## REMARKS

**Amendments to the Drawings:**

Fig. 5

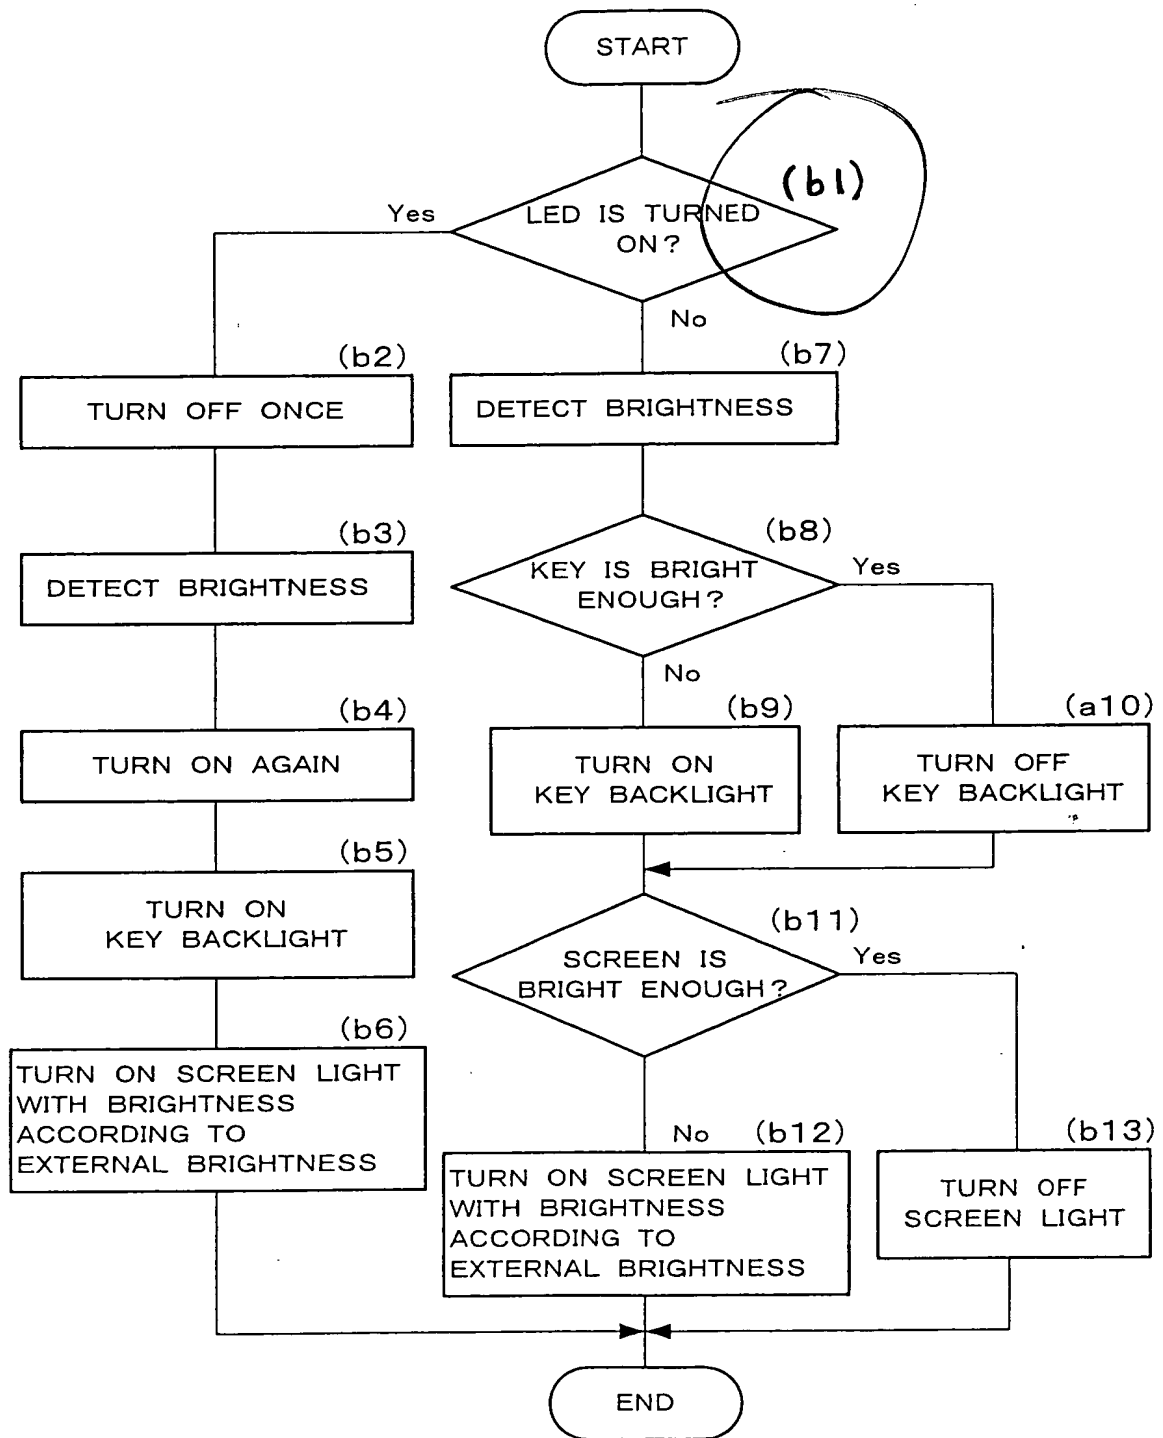
In Figure 5, the reference item "(b1)" has been added to correspond to the written description at page 12, line 8.
